**Meeting of the Central Valley Flood Protection Board
June 24, 2011**

**Staff Report – Encroachment Permit
Reclamation District No. 17
Landscape Planting, San Joaquin County**

Consider approval of Permit No. 18518-A (Attachment B)

Irrigation

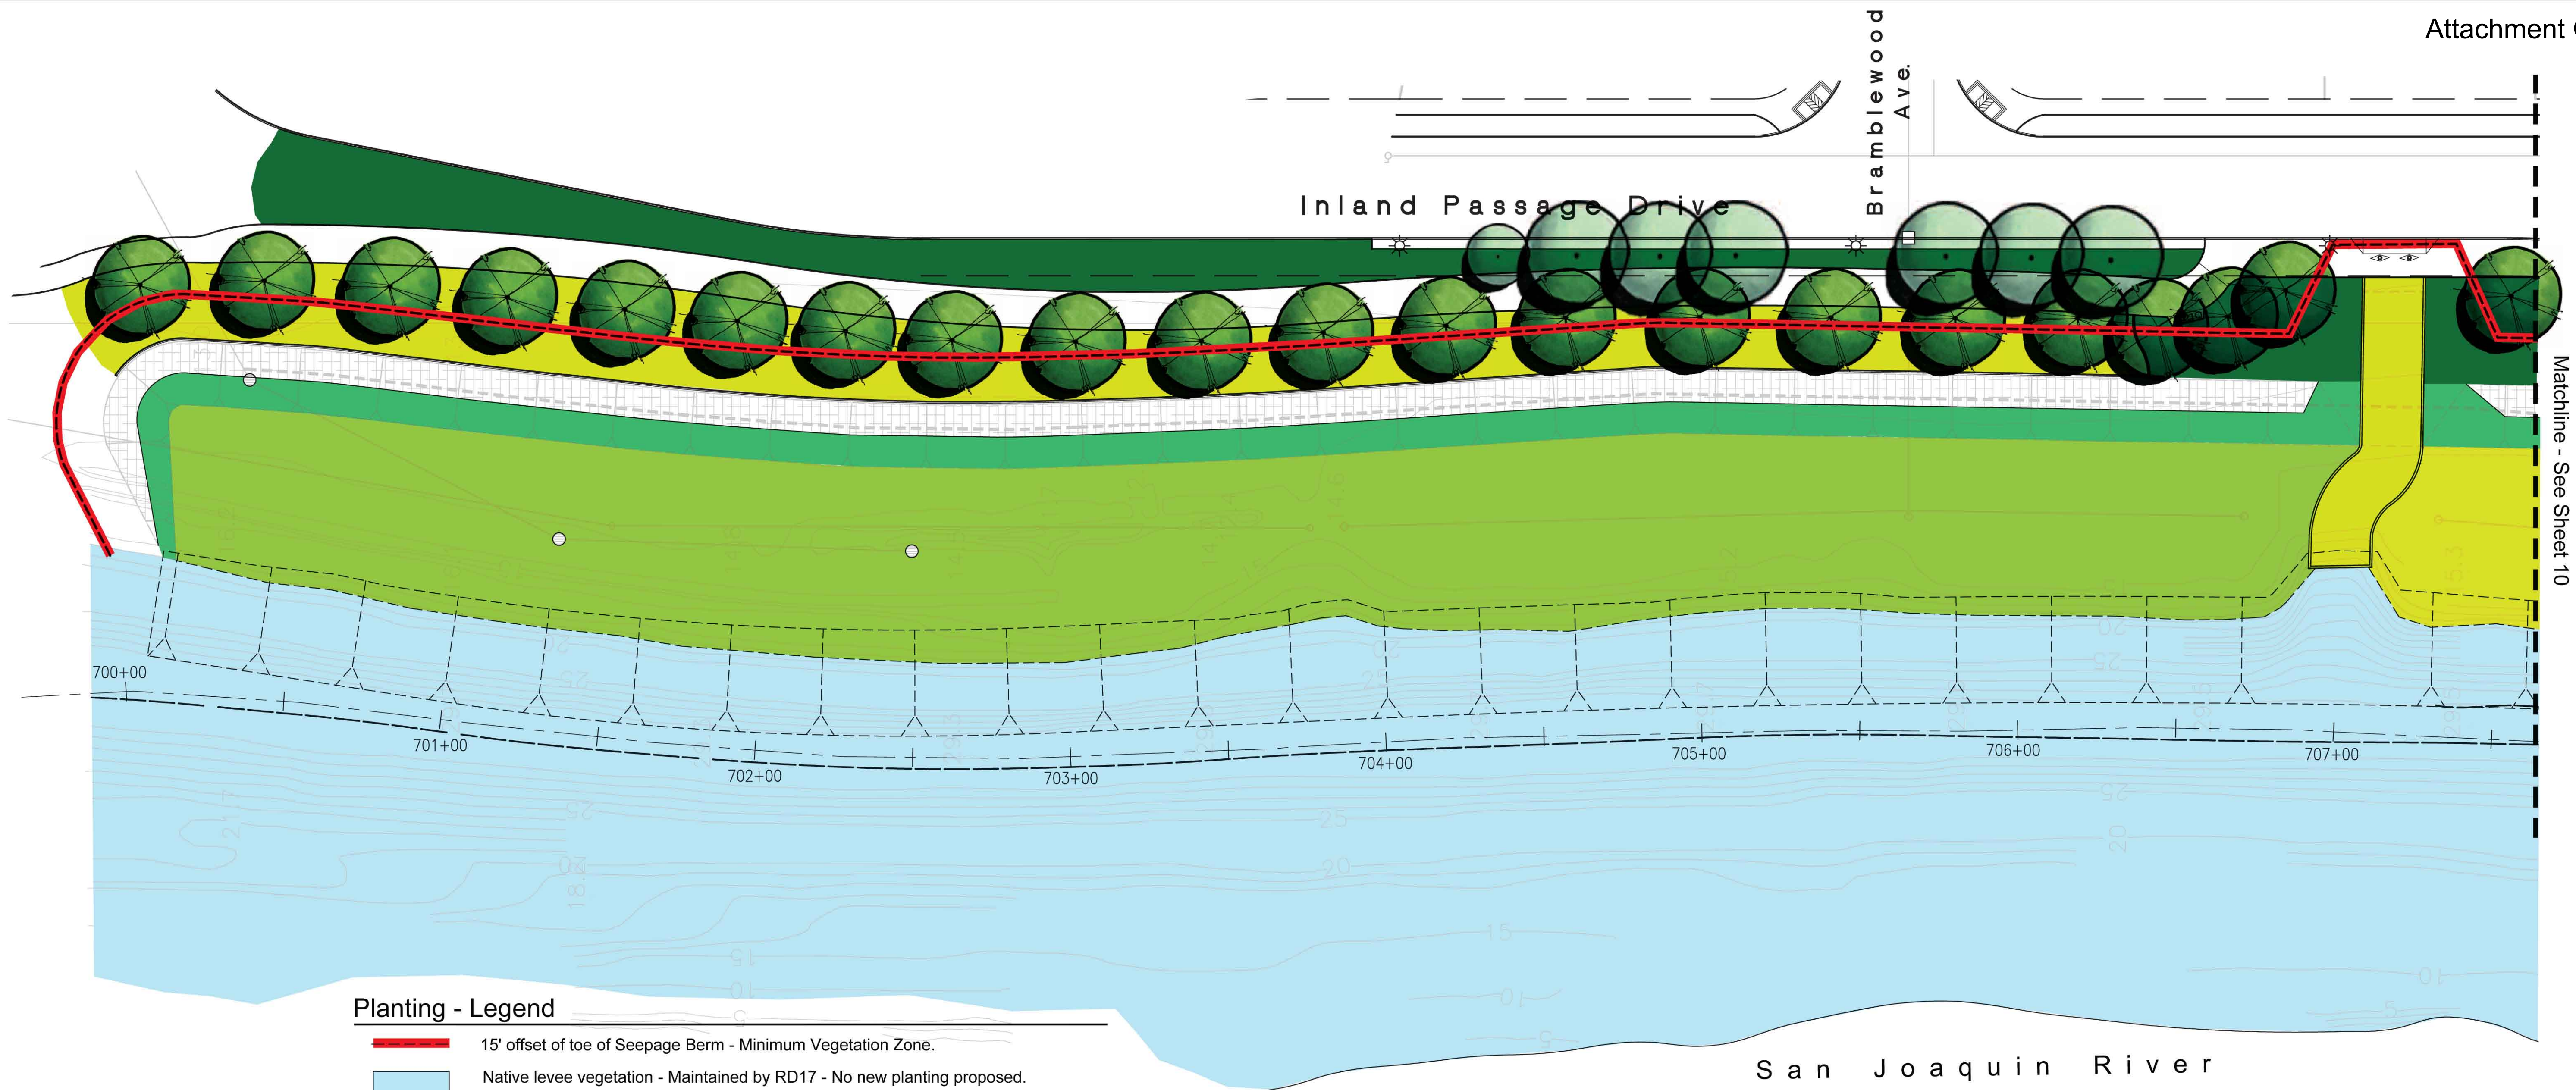
The only technical concern of the aforementioned encroachments is the irrigation improvements. The concern is that during the non-flood season the irrigation improvements introduce a new water source at this site (artificial rain) in an unknown quantity. The permit will include language that requires the permittee to monitor the existing underseepage collection system during operation of the irrigation improvements by submitting to a plan for monitoring that is acceptable to the Board with consideration for any mitigation needed to assure the system operates as designed at all times.

THIRTY-SEVEN: The permittee shall submit a plan for monitoring the existing underseepage collection system during operation of the irrigation improvements that is acceptable to the Central Valley Flood Protection Board with consideration for any mitigation needed to assure the system operates as designed at all times. This plan is to assess the first season of use after installation or longer if needed.
